Special Bulletin

SP15-302

KNEELING ALARM REPLACEMENT Prevost vehicles

Figure 1

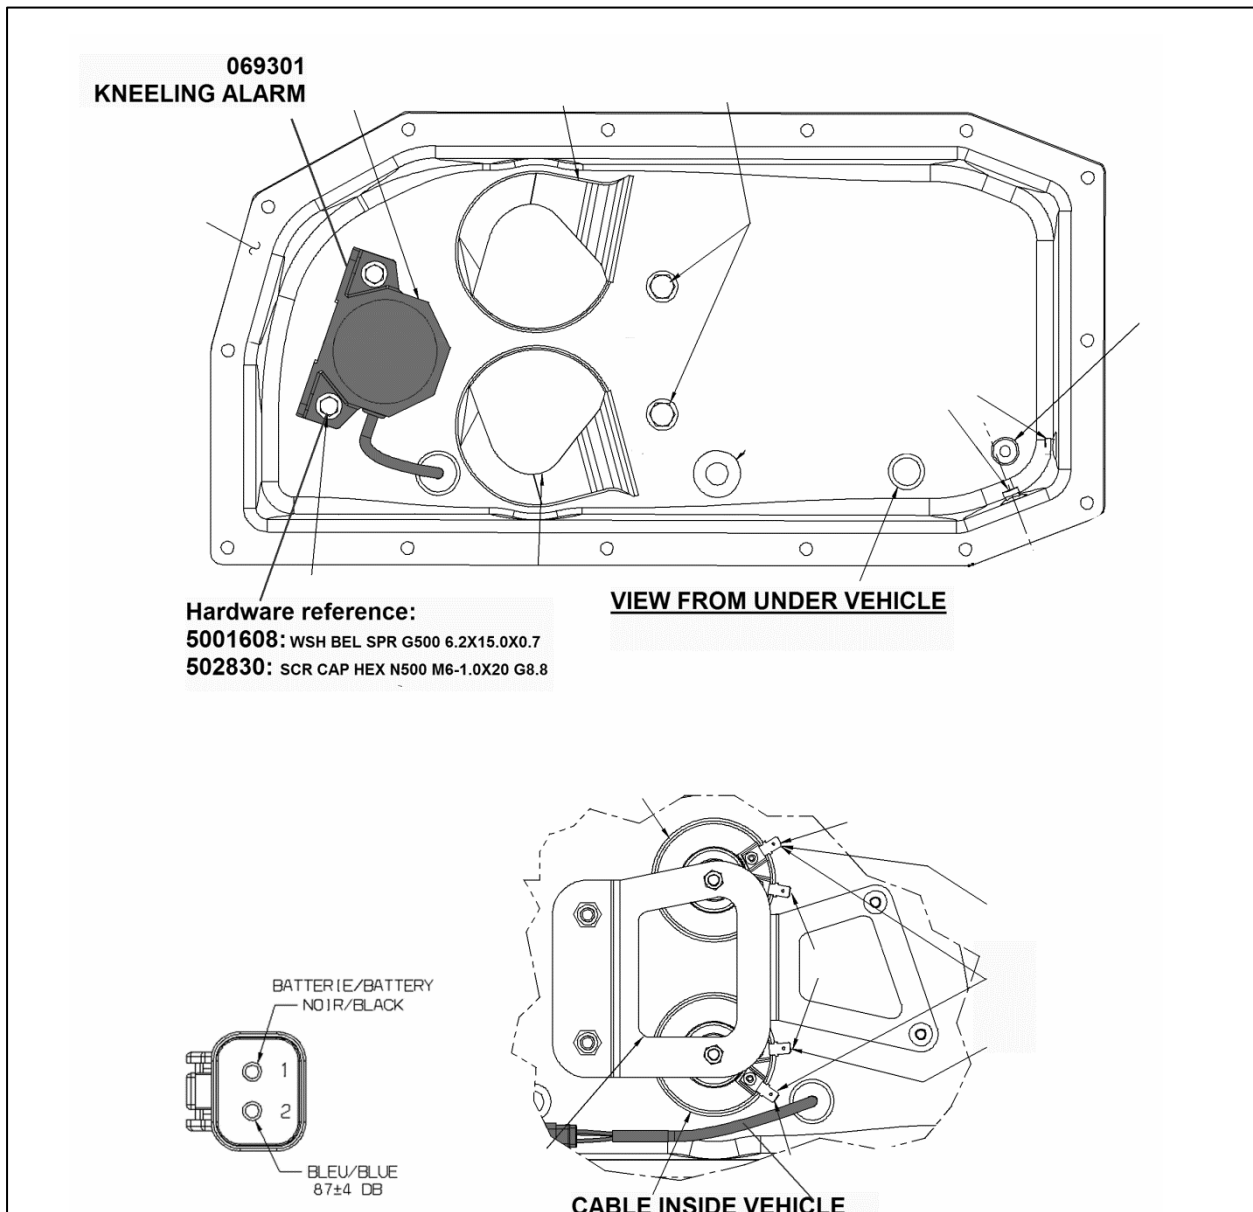
On the vehicles affected by this bulletin, perform the replacement of the kneeling alarm buzzer assembly.

- 1) Lift vehicle with column lifts.
- 2) Locate the horn housing recessed in the under floor, curb side, under the entrance staircase.
- 3) Replace the kneeling alarm by 069301 (fig. 1). Pass wiring thru floor to inside of vehicle and reconnect. New connection is Blue –Black.
